ITEM 5: 202001290006 – Broadway Professional Park (Development Plan)

A Development Plan for a 22,400 square foot multi-tenant building

Staff Recommendation

Site Plan

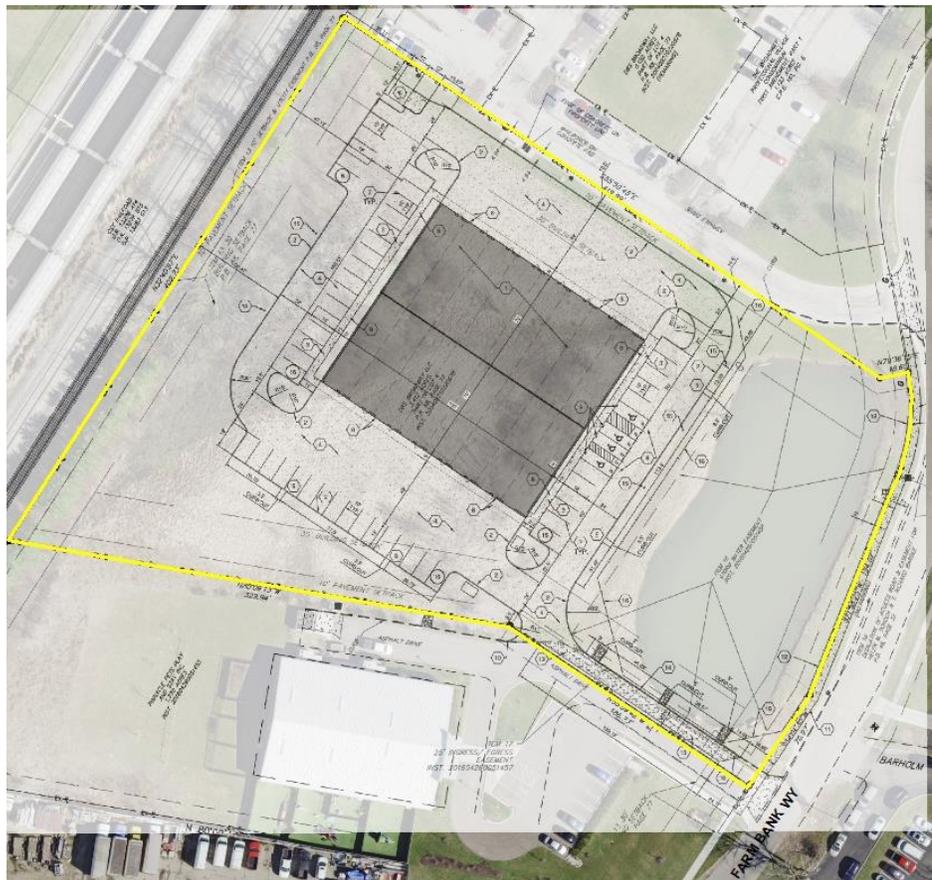
The site is proposed to be accessed from an existing, 25-foot, shared access drive with the neighboring Pinnacle Pets site to the south. Half of the drive is located on the site with the other half on the property to the south. A 24-foot drive is proposed on the site which will loop around the building providing access to the tenant spaces for truck loading and to the parking spaces for employees and visitors. Each truck loading area (proposed on the north and south sides of the building) will be 30-feet in width to accommodate box trucks and small delivery vehicles on the site. Plans indicate that white striping and pavement

markings will be utilized unless otherwise noted; however, the plans show the parking space striping to be yellow. Staff is not supportive of the yellow and the plans will need to be updated to state that all markings will be white to remain consistent with other development in the area.

A five-foot sidewalk is proposed along the front and rear sides of the building and will connect with the asphalt areas on the north and south sides to allow for continuous ADA connectivity on the site. Another sidewalk is proposed along the front of the site, connecting with the existing sidewalk in front of Pinnacle Pets, along Farm Bank Way and with the existing drive apron to the north. Reinforced fencing is proposed along Farm Bank Way, between the sidewalk and pond.

Stormwater will drain into an existing regional retention basin on the property, located in the front of the site. Other sites utilizing this basin include Pinnacle Pets to the south and the Broadway Professional Village to the north. Staff preliminarily reviewed stormwater for the property and will complete a more in-depth review during the Site Improvement Plan phase including any necessary maintenance agreements for the pond. Reinforced fencing is proposed in areas around the pond where adjacent to either a drive aisle, parking spaces or a sidewalk, as was done on other sites including Parkway Centre North.

An existing wetland is located in the southwestern portion of the property, and a portion of the proposed drive aisle on the west side of the building will be located in the wetland area. The applicant has indicated that they plan to do mitigation for the wetland. They are currently on notifying and working with USACE (US Army Corps of Engineers) and OEPA (Ohio EPA) regarding the impact to the wetlands area and will provide evidence of approvals for the proposed mitigation once it is received.

Farm Bank Way/Front/East Elevation

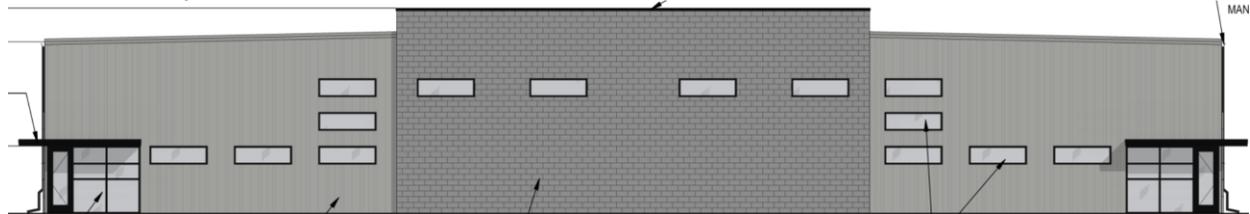
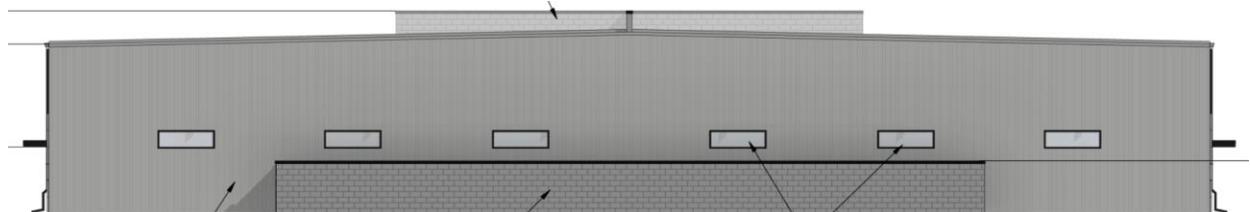
The building is proposed to be approximately 22,400 square feet in size with a maximum proposed height of 24'4". The building's façade is proposed to be finished primarily in vee-rib vertical metal siding (Tueblite "Anodized Black") and split-face concrete masonry blocks (RockCast "Smoke House"). No main building entrance is proposed, but a total of 16 tenant spaces are proposed in the building, each with its own entrance and bay doors on the exterior of the building, with eight of each proposed on the building's sides (eight on the north and eight on the south). The doors are proposed to be window glass with dark gray frames (Vitro Glass "Solar Gray"). The bay doors are proposed to be white metal (Varco Pruden Buildings "Cool Arctic White") with windows located in the middle of the doors. Other building features include transom windows on both the front (Farm Bank Way/east) and rear (west) sides of the building, a flat metal roof (Varco Pruden Buildings "Cool Zinc Gray") and black gutters and downspouts (Varco Pruden Buildings "Cool Ebony") to provide additional architectural interest.

The proposed materials do not currently comply with the approved zoning text for the site, which requires building materials to be brick, stone, cultured stone or glass. Stucco, synthetic stucco, split face block, precast concrete and wood trim may also be used but cannot exceed 50 percent of the building elevations. Although the proposed metal siding split face block are also utilized on the Pinnacle Pets building adjacent to the south, the Pinnacle Pets structure also incorporates brick on the east and north elevations as well as a portion of the south elevation where visible from the public right-of-way (not blocked with fencing/screening). In order to comply with the approved zoning text, brick, stone or cultured stone will need to be added to the elevations and/or the amount of glass increased on the east elevation. These materials should also be added or increased on the north and south elevations where visible from the public right-of-way. The west elevation, adjacent to the railroad tracks, is not required to utilize brick, stone or cultured stone per the zoning text.

An elevation for the dumpster's enclosure was provided as well. It is proposed to be finished in the same split-face concrete block as proposed on the building and have vee-rib metal gates. Staff is supportive of the split-face concrete block as it complements the building and is the same material used on the Pinnacle Pets dumpster enclosure; however, staff is not supportive of having the gates finished in metal and believes they should be finished in 100 percent opaque, stained wood.

1. A deviation shall be granted for a reduction in the amount of parking spaces to permit a minimum of 53 spaces on the site.
2. The building materials shall meet the requirements of the Broadway Professional Village Zoning Text, including additional brick, stone, or cultured stone on the east elevation and adding/increasing those materials on the north and south elevations where visible from the public right-of-way, having at least 50 percent of the building being finished in those materials.
3. The dumpster enclosure gates shall be finished with 100 percent opaque, stained wood.
4. Landscaping in compliance with section 1136.06(b), for truck vehicular use areas, shall be required along the north and south truck parking and loading areas.
